Re: Construction of Dyrick Hill Windfarm comprising 12 no. wind turbines and related works.
Townlands of Ballymacmague North, Ballymacmague South, Ballynaguilkee Lower, Ballynaguilkee Upper, Broemountain, Carrigaun (Mansfield) and others, Co. Waterford.

An Bord Pleanála Ref: No. ABP-312434-22: Dyrick Hill Wind Farm

RE: Proposed Dyrick Hill Wind Farm, County Waterford (Ref. No. ABP-312434-22): A Strategic Infrastructure Windfarm Development consisting of 12 wind turbine generators, 110kv substation, connection to the national electricity grid and associated and ancillary works at Ballynaguilkee Upper, Broemountain, Corradoon, Dyrick, Lickoran, Lickoranmountain, Lisleagh, Lisleaghmountain, Lyrattin and Scartmountain, County Waterford.

Figure 1: Scart Mountain Wind Farm Site showing 2RD of Dyrick Hill Wind Farm site.

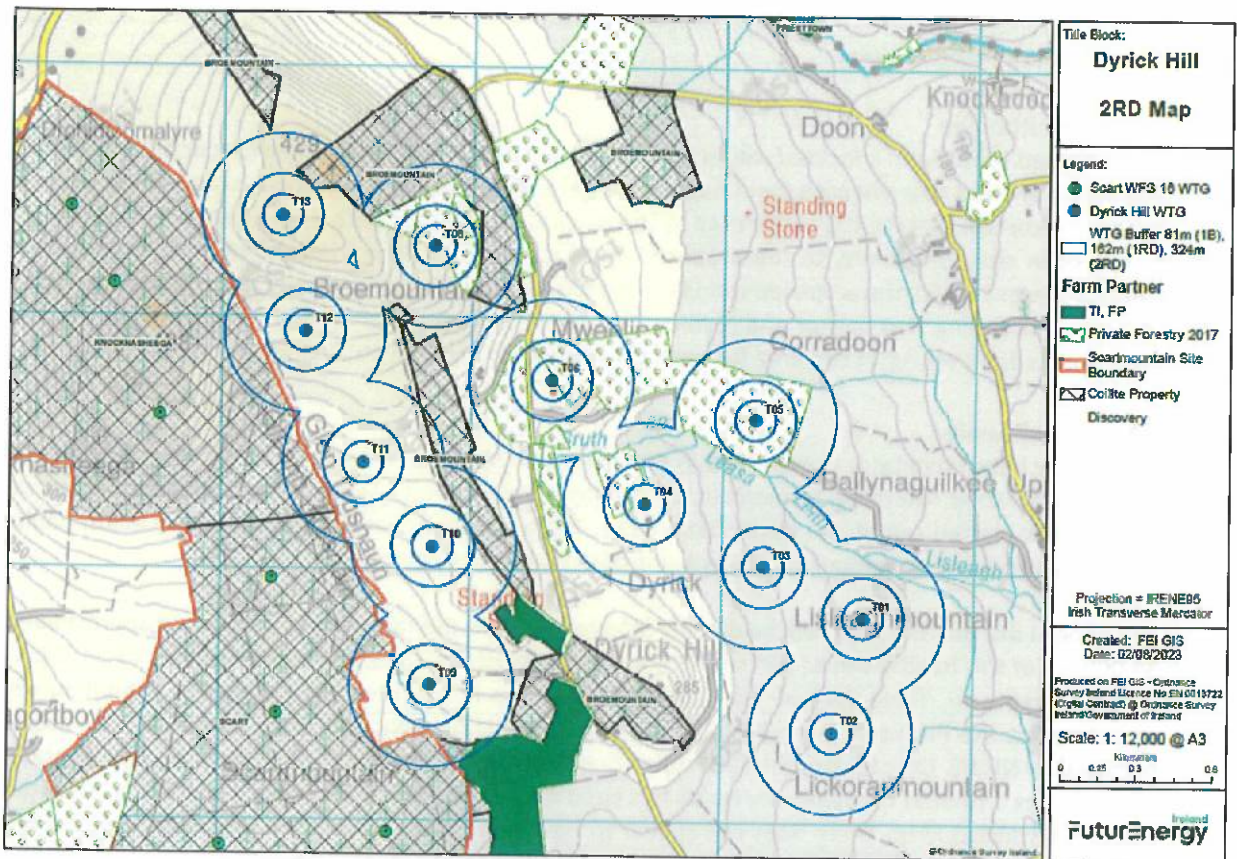
We would note that the intention of this set-back provision of the Ministerial guidelines is to address issues in relation to potential wind take and to protect the potential for wind farm development on adjoining property. As such, where turbines are located less than two rotor diameters from neighbouring properties, but there is no practical development potential on the neighbouring property, we would accept that a breach of this 2RD guidance limit could be acceptable. We therefore have no issue with the siting of the Proposed Wind Farm's T8 and T6 where there are minor 2RD exceedances in relation to Coillte owned lands, on the basis that the scale of these lands would be insufficient to enable development of turbines. However, the 5No. turbines on the western boundary of the Proposed Wind Farm site (T09 – T13) are all exceeding the 2RD requirement and are adjoining lands which FEI currently enjoys exclusive land rights to, and that are the subject of our active Scart Mountain Wind Farm development project (Refer Figure 1 overleaf).

The intent of the 2006 WEDGS is to preserve the development potential of neighbouring property for wind farm development. It is of significant concern that the Proposed Wind Farm fails to have regard to these Ministerial Guidelines.

An Bord Pleanála must have regard to the 2006 WEDGS, as required under Section 37G of the Planning and Development Act, and in circumstances where there is obvious wind energy development potential as is the case on our adjoining lands, Section 5.13 is clearly relevant to its consideration of the Proposed Wind Farm application. We see no objective, reasonable justification for not requiring strict compliance with the set-back prescribed in the 2006 WEDGS.
